Save Oak Savanna

Draft Environmental Impact Report (DEIR) Assessment

4.30.16

Red highlighted areas below show extensive use of retaining walls across development both on height and length
GRAPHIC SCALE: 1"=40'

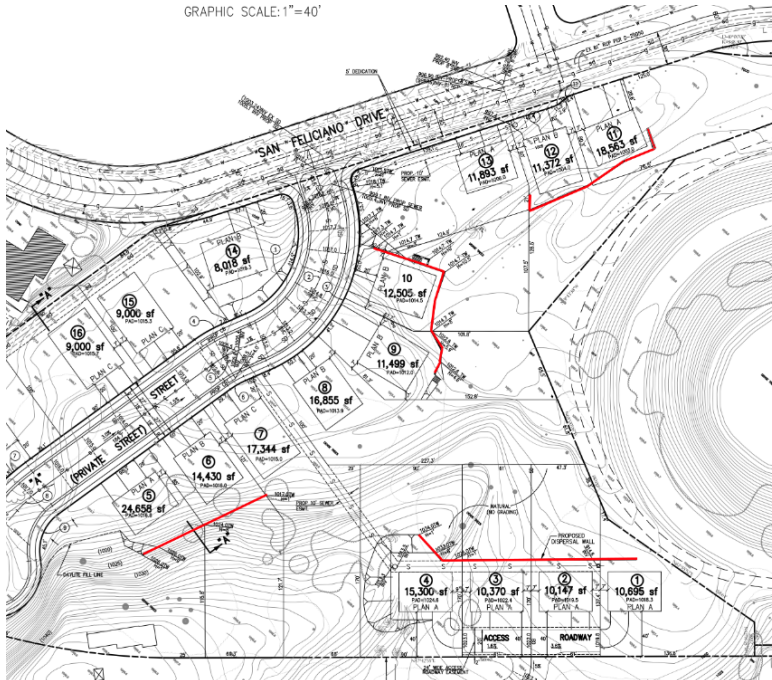
The DEIR indicates that there will be an extensive network of retaining walls.

- One wall 140 ft. long with a height varying from .5 ft. to 10 ft.
- One wall 80 ft. long with a height of 10 ft.
- Two walls 120 ft. long with the heights reaching 19 ft.
- One wall 120 ft. long with variable heights up to 5 ft.
- One wall 60 ft. long with a variable height up to 8 ft.

The amount of retaining walls is in violation of Guideline 1 of the Mulholland Scenic Parkway Specific Plan (MSPSP) which states: “Minimize the amount of grading and the use of retaining walls. Design structures and grading to fit the natural topography and existing conditions of the site, rather than making changes in the topography to accommodate the structure...”. MSPSP further indicates that when there are retaining walls, they should be constructed in a way that approximates the natural terrain that the retaining walls are impacting. The developer deliberately goes against this instruction and proposes large retaining walls to maximize the number of houses.

As to specifics, MSPSP allows a maximum height of 10 ft.; so the proposed project is out compliance with Guideline 28 for one of the retaining walls. The proposed project is also out of compliance with a number of Los Angeles City sections and will require that a Zoning Administrator Determination be granted for the retaining walls.

Page I-1 specifically states, “The Project would utilize four retaining walls ranging from .5 to 19 feet in height in lieu of slopes...”. This language suggests a single wall to a height of 19 ft., not walls with a “variable” height of 19 ft. Also, Page III-12 states that, “Project proposes six retaining walls with a total of 510 linear feet.” which does not match sentence above referencing four walls.

1. The exact height of each retaining wall needs to be clarified
2. The proposal needs to be in compliance with the Mulholland Scenic Parkway Specific Plan's limits on the maximum height of retaining walls
3. The retaining walls need to be in compliance with Guideline 1 of the Mulholland Scenic Parkway Specific Plan
4. The retaining walls may need to be relocated in order to protect trees near lots 1, 3 10, 11, and 12. A mitigation plan must be presented
5. Developer must provide a mitigation plan in case trees are damaged during construction or within a certain period following construction

Area covered to determine % of two story homes

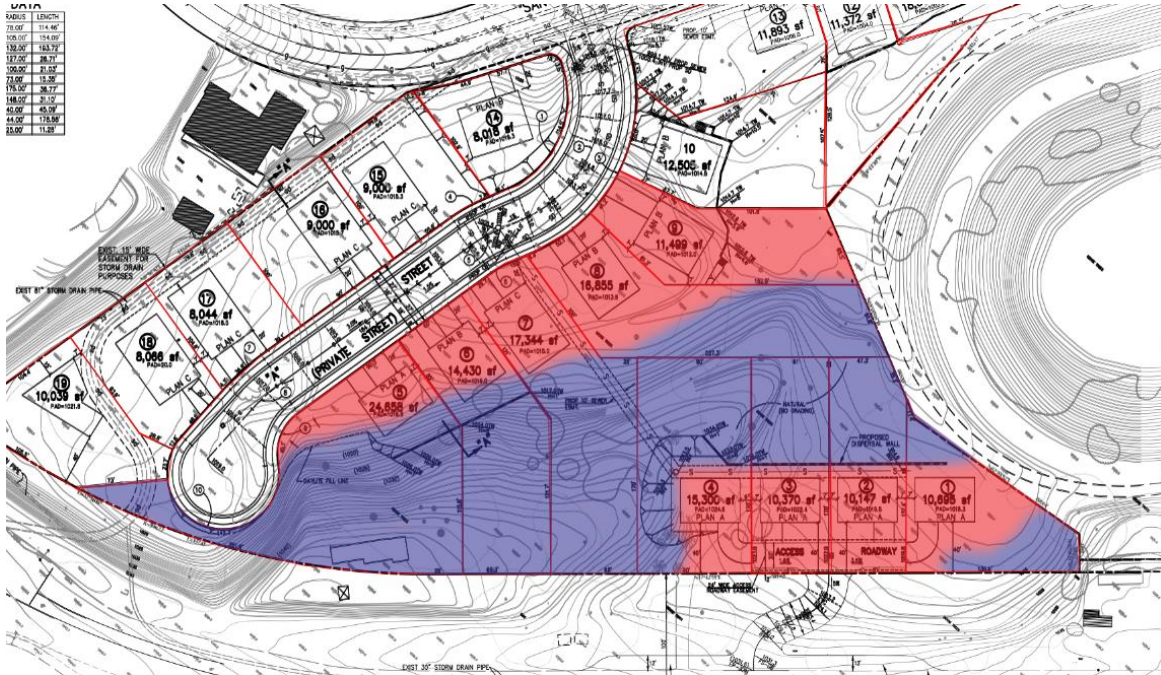
Given that developer has committed to build homes that match the character of the neighborhood, of the 175 homes that are directly around the proposed development (see below for coverage map), only around 8% of them are two story homes. The proposal for 100% two story homes does not fit the character of this neighborhood as the average square feet of homes in this area is 2,149 while a full two story development would have homes averaging 4,000 square feet (55% larger than existing) and possibly as large as 4,800 square feet.

Area in blue highlights hillside that would greatly reduce the usable area of these lots, in some cases giving certain homes minimal backyard space

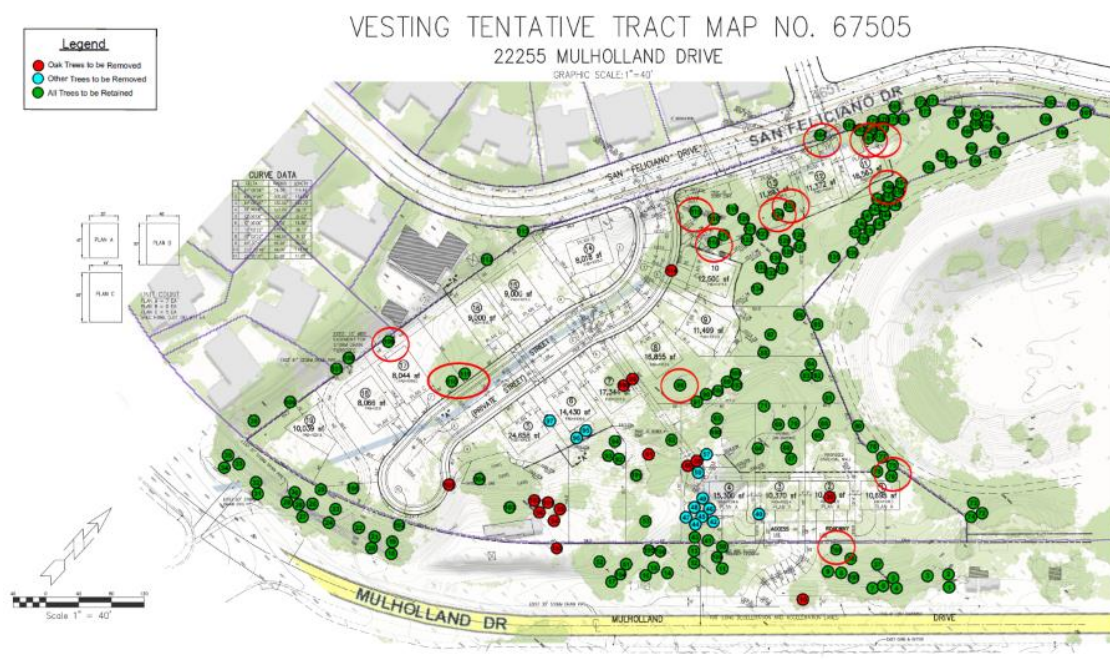
In addition, while the average lot sizes in the proposed development are approximately 12,000 square feet (which does fit the existing character of the neighborhood), eight of the proposed homes use a small percentage of their lot with coverage. These eight homes have nearly no usable space in which to have a yard (see blue shaded areas below) while being responsible for unusable hillside. It does not fit with the existing character of the neighborhood to have large, unusable backyards and small, cramped front yards.

In effect while lot coverage looks small on the surface, these houses actually cover nearly all the usable lot making effective lot coverage (more than 50% in all the cases highlighted below). The Proposed Project's layouts of the homes on the lots are in stark contrast to the existing character of homes in the neighborhood.

1. Request that DEIR reflect the past statements of developer that no unit would be taller than 2 stories
2. Request that lots bordering southern property line (15-19) and San Feliciano (11-14) cannot exceed one story in height based on conversations with developer when they were still known as DS Ventures
3. Request that eight homes highlighted in red (Lots 1-8) in map above make better use of lots to match existing character of the homes in the neighborhood

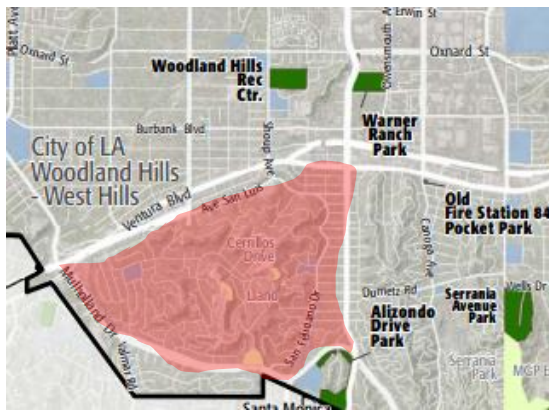
In map below note that in the area bounded by Ventura, Topanga and Mulholland (highlighted in red) where there are nearly 4,000 homes there are currently zero parks. Given that there are so few open spaces left in this area, this development presents a perfect opportunity to add a desperately needed small pocket park to the neighborhood.

Lot 11 below and adjacent Girard Reservoir

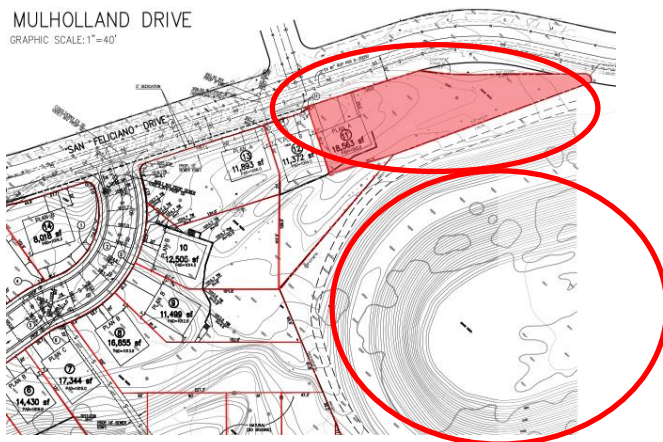
One proposal would be to remove or reduce Lot 11 (18,653 sq ft) and add a park in the corner closest to the LADWP pump station. It's an ideal location for a small park, especially considering the success of the Fire Station Park on Canoga and Ventura (8,200 sq ft). Options include Developer building Park with HOA maintaining the park or donating the parcel to the City of Los Angeles or to the Santa Monica Conservancy. In addition, there is currently a partnership between the LADWP and the Santa Monica Conservancy to make the Girard Reservoir a natural parkland that will include public access. The combination of this small pocket park for children and a ¼ mile walking track at the reservoir creates a unique and enriching addition to the community.

Instead of just providing lip service in meetings, the developer should come to the table with a real plan in the DEIR on how to give back to the community they plan on profiting from with a viable option of a pocket park that not only benefits the 19-unit project, but the neighborhood at large

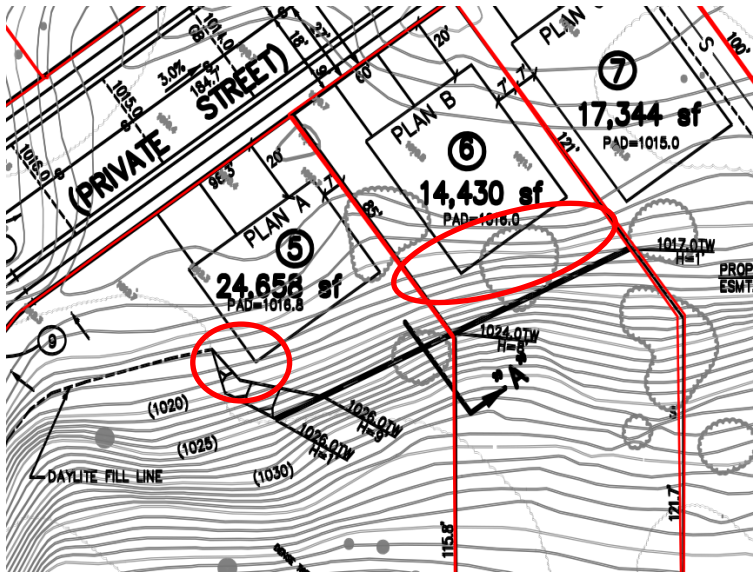
Lot 5 cuts too far into the hillside and the pad is too close to hillside cut given the 35-40 ft. elevation gain in that area. Lot 6, while looking to meet lot coverage requirements actually covers most of the "usable" lot while most of lot is behind large retaining wall and consists of all hillside. See the map below.

Action: Proposing to remove Lot 5 and 6 or reconfigure according to City guidelines and MSPSP Guidelines.

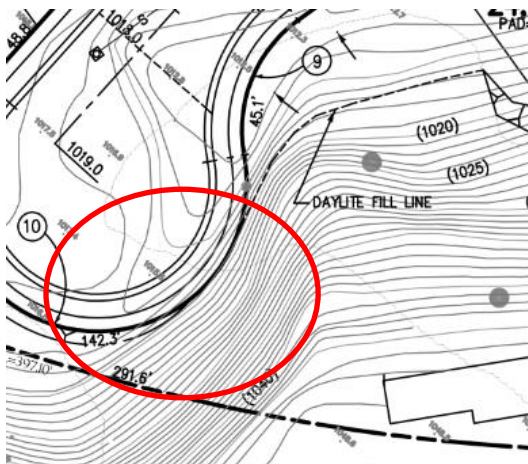
The end of the cul-de-sac on the proposed street cuts deep into hillside. Given the steep elevation gain surrounding the cul-de-sac, there is concern around the hillside eroding into the Street and possibly collapsing altogether into the street. See the map below.

There is also concern over who will be responsible for the maintenance and upkeep of the steep hillsides around the cul-de-sac. Some party must be assigned responsibility.

1. Provide community with more specificity on how this particular hillside will be supported to prevent erosion and collapse of hillside
2. Determine who will be responsible for maintenance and upkeep of steep hillsides around cul-de-sac. Homeowner Association, City of Los Angeles, homeowners adjacent to hillside?

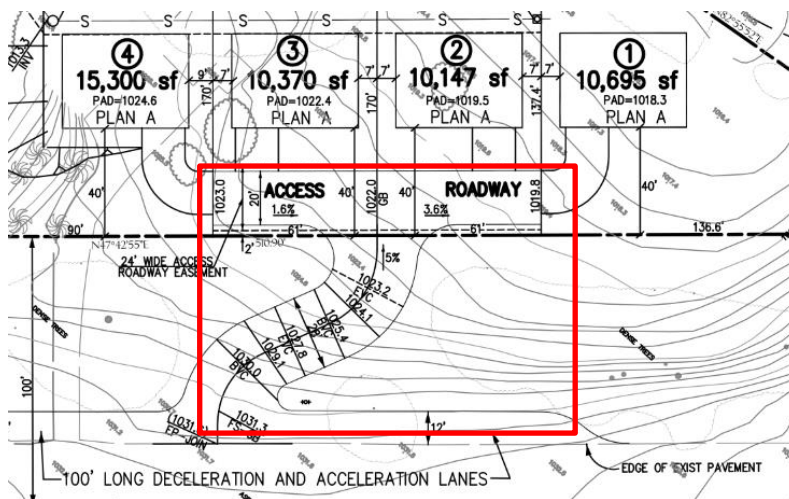
The community has concerns for the access roadway and common driveway connecting lots 1-4. Who is responsible for maintenance and upkeep of the access roadway and common driveway? Would the residents of lots 1-4 have to assume responsibility for the maintenance and upkeep of the access roadway and common driveway after construction? Would the residents be informed of their common obligation? Is the City of Los Angeles obligated to assume responsibility for the maintenance and upkeep of the access roadway and common driveway after construction? What if the City decides not to obligate itself with these new requirements? How does that impact the Proposed Project?

There is also concern that the deceleration and acceleration lane could become a passing lane for vehicles on Mulholland Drive. Vehicles driving on Mulholland Drive frequently exceed the speed limit and perform dangerous maneuvers such as passing vehicles on the shoulder and in the center turn lane. The community believes that the deceleration/acceleration lane will contribute to and exacerbate existing dangerous behaviors of drivers on Mulholland Drive.

There is also concern as to who is responsible for maintenance of the 100 foot long deceleration and acceleration along Mulholland Drive? Would the residents of lots 1-4 have to assume responsibility for the maintenance and upkeep of the 100 foot long deceleration and acceleration lanes after construction? Is the City of Los Angeles obligated to do so? What if the City decides not to obligate itself with these new requirements? How does that impact the Proposed Project?

Given that the developer has not approached the Mulholland Scenic Parkway Design Review Board, what happens to the 4 lots adjacent to Mulholland if deceleration/acceleration lanes or common driveway unto property is not approved?

1. The community needs specifics on who owns and is responsible for maintenance and upkeep of the common driveway and access road connecting lots 1-4
2. The community needs to understand how the developer will ensure the safety of drivers on Mulholland Drive around the deceleration/acceleration lane
3. The community needs specifics on who is responsible for the maintenance of the deceleration and acceleration lanes on Mulholland Drive
4. The community believes that submitting a DEIR proposal before they have even approached the MSCDRB to get their input for something directly affecting Mulholland Drive is presumptuous and could severely affect the final tract map
5. Address equestrian trail running parallel to Lots 1-4 and mitigation strategy in DEIR

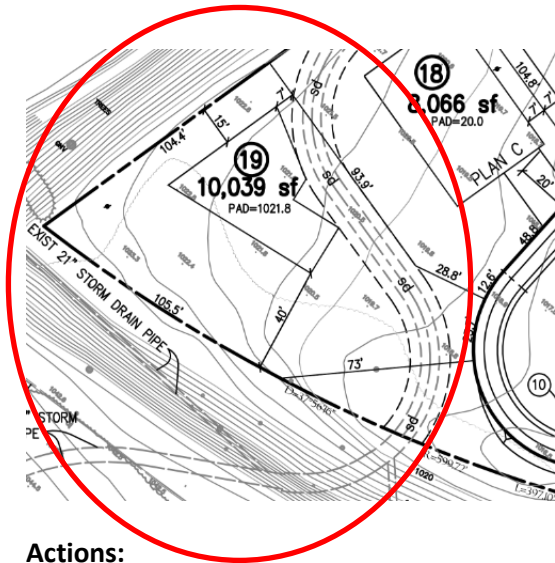
Pad doesn't meet 15 ft. easement requirements and there is no marked driveway on the drawing. In addition storm drain will run directly under the driveway of lot 19 driveways and right up against the house creating serious issues if the storm drain needed to be accessed.

The home of lot 19 is also listed as a Spec Home in DEIR. What exactly does developer want to do with this lot? Is there a plan to sell this lot separately?

In addition, Table III-1 (Proposed Lot Summary) shows that access point to this lot is a "Specialized/New Public Street". What does that mean? Where would this "Specialized/New Public Street" be?

1. Inform community as to what “Specialized/New Public Street” means, where it would be located and all relevant details
2. Inform community as to what “Spec House” is and what the intentions around the “Spec House” are and all relevant details
3. Highlight driveway on lot 19
4. Inform community as to what mitigation strategy is for the easement issues
5. Provide mitigation plan for accessing the storm drain

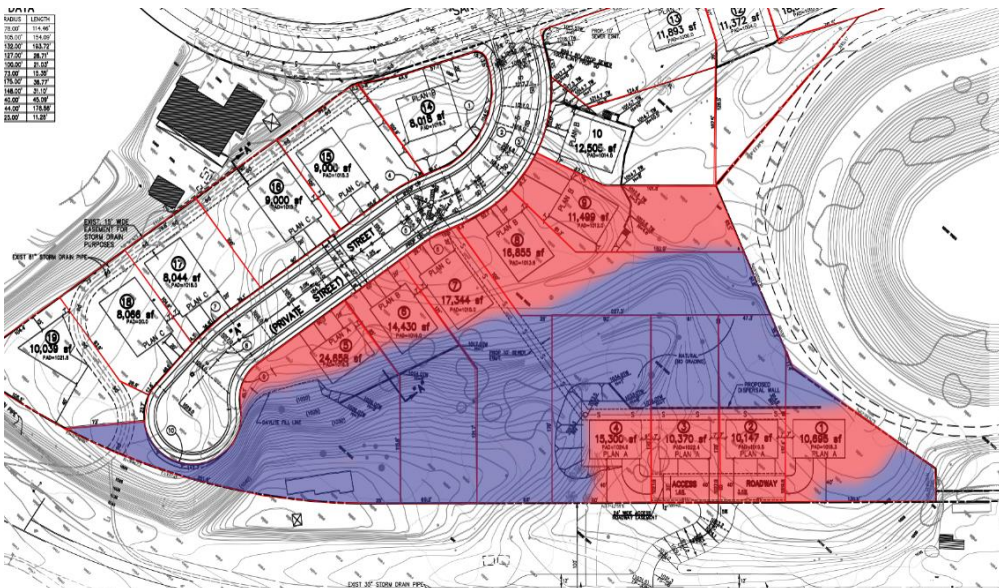
Given so many protected Oaks would be located in people's yards, what assurances are there that these trees will be protected and not cut down by the homeowners at some point?

In addition, there is a question as to who is responsible for the access roadway and common driveway on Mulholland for lots 1-4.

1. Community recommended on April 11, 2016 meeting that it might make sense to create a common area (in purple above) that would be managed by an HOA which would not be part of the proposed lots. This would protect Oaks while reducing lot sizes with large amounts of unusable land. This would also serve to maintain any common areas including the shared driveway off of Mulholland.
2. HOA could also be responsible for maintaining the public street/private street, the access roadway, the driveway connecting Mulholland to lots 1-4 as well as the 100 foot long deceleration and acceleration lanes if approved
3. HOA could also be responsible for maintaining the network of retaining walls throughout the development
